ADDENDUM NO. 1

DATE OF ISSUANCE: February 10, 2020

PROJECT: Wayland High School Stadium Improvements

ARCHITECT'S PROJECT NO.: 20-112.00

ELECTRICAL DETAILS

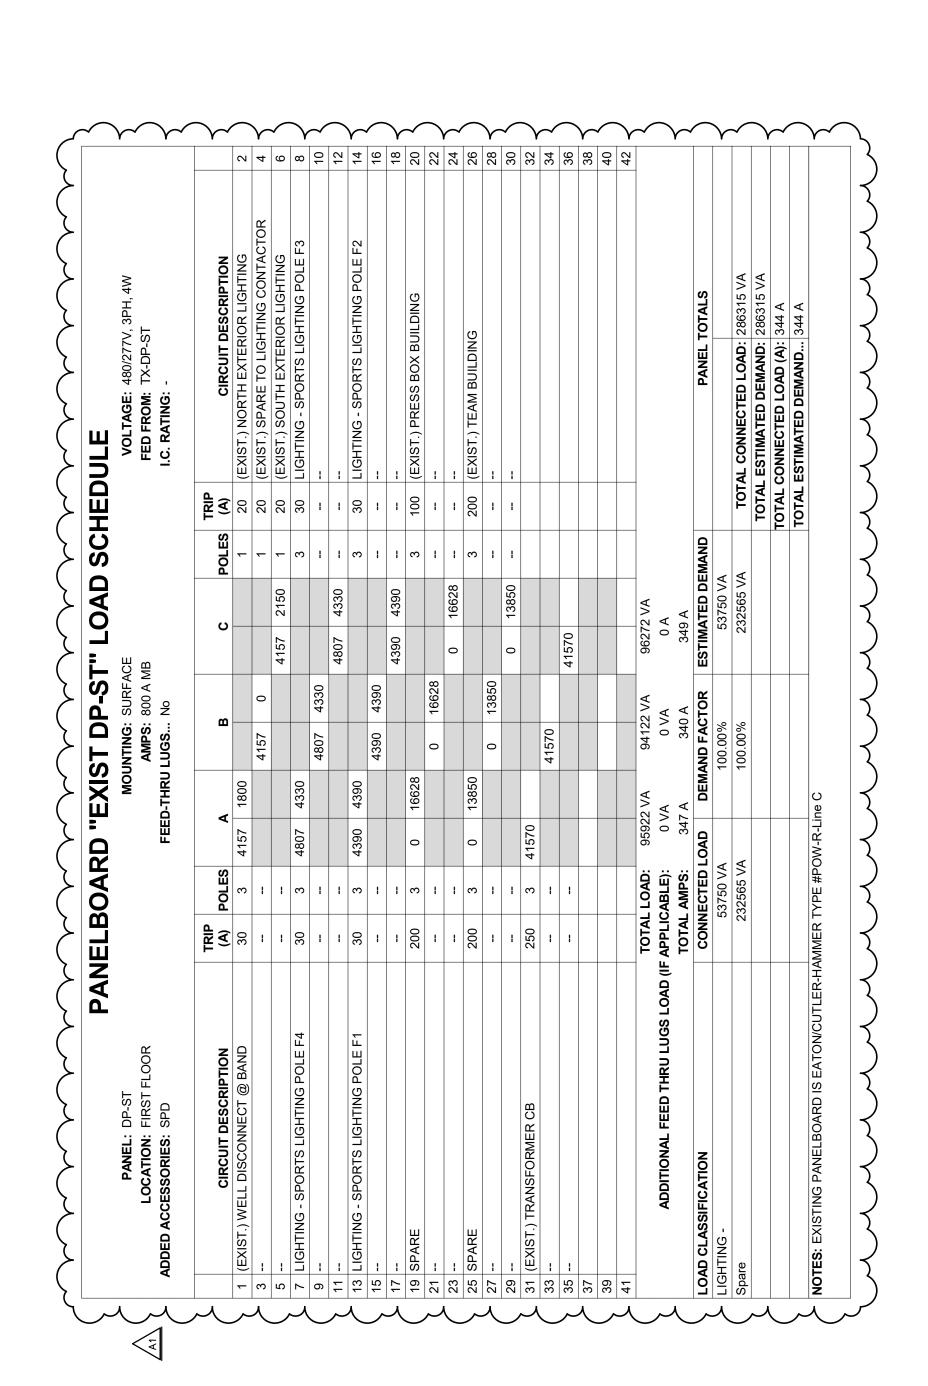
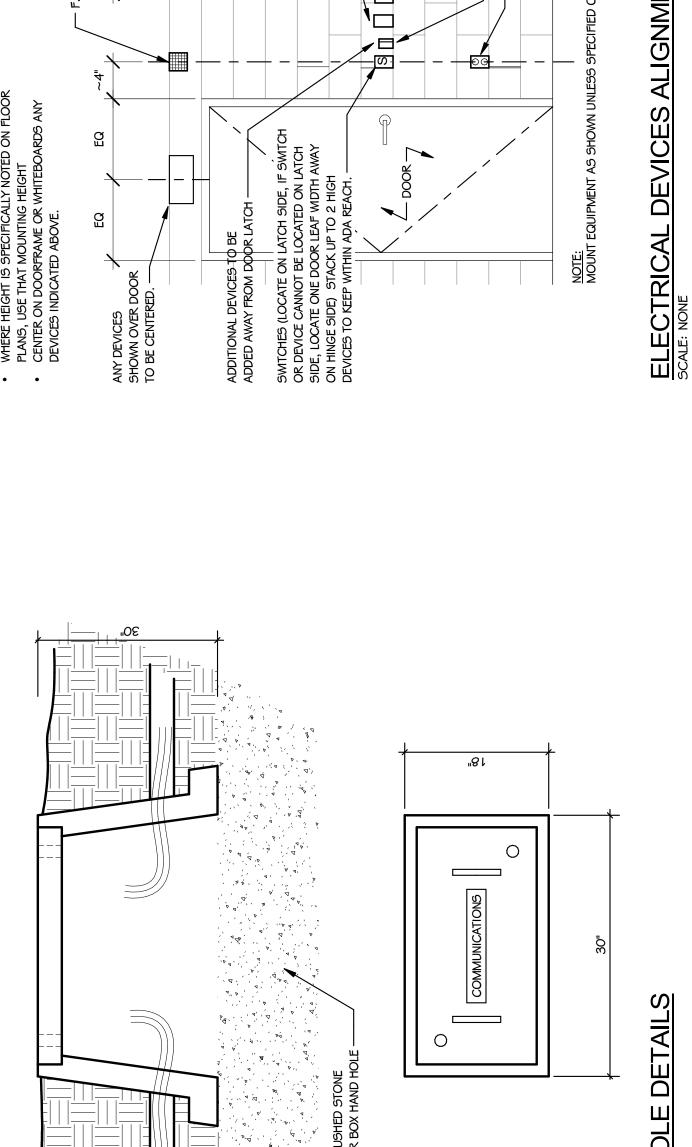
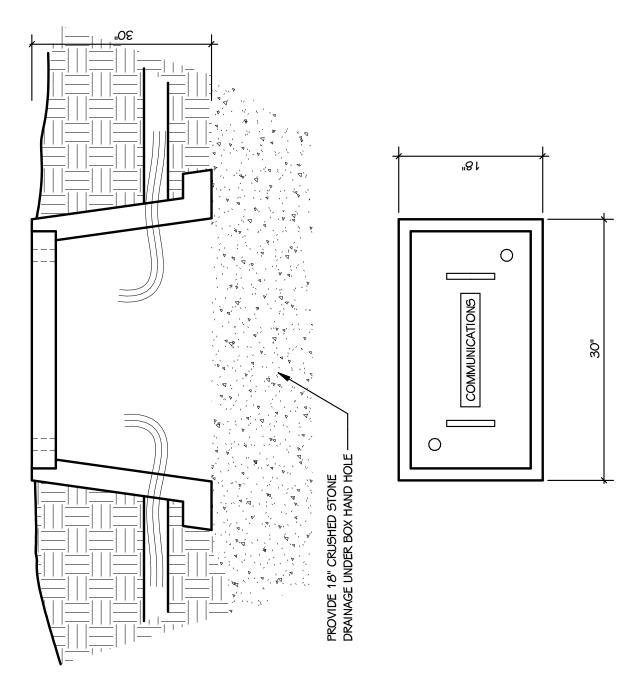
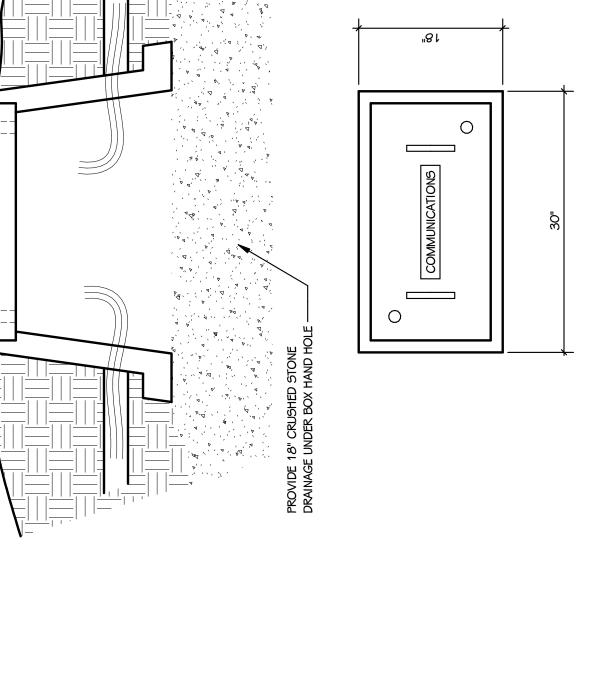
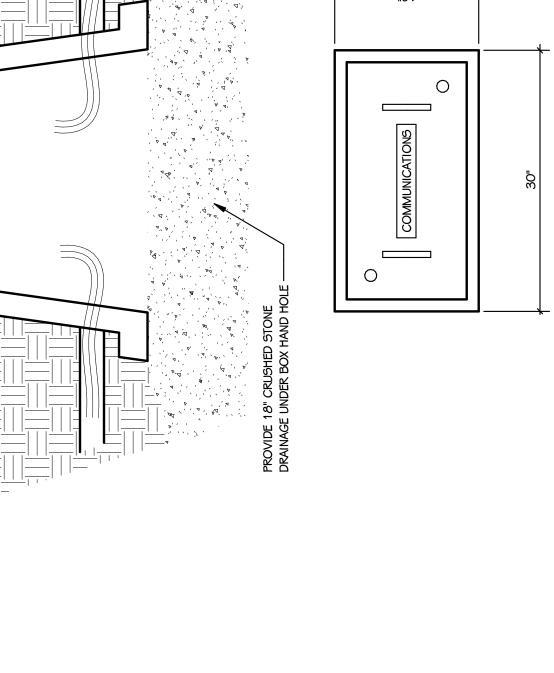
ADD-1 Item No. D-2 - Sheet E 401 - ELECTRICAL DETAILS

Refer to Sheet E 401 (re-issued).

Add stadium distribution switchboard "DP-ST" panelboard load schedule to show existing/new electrical loads.
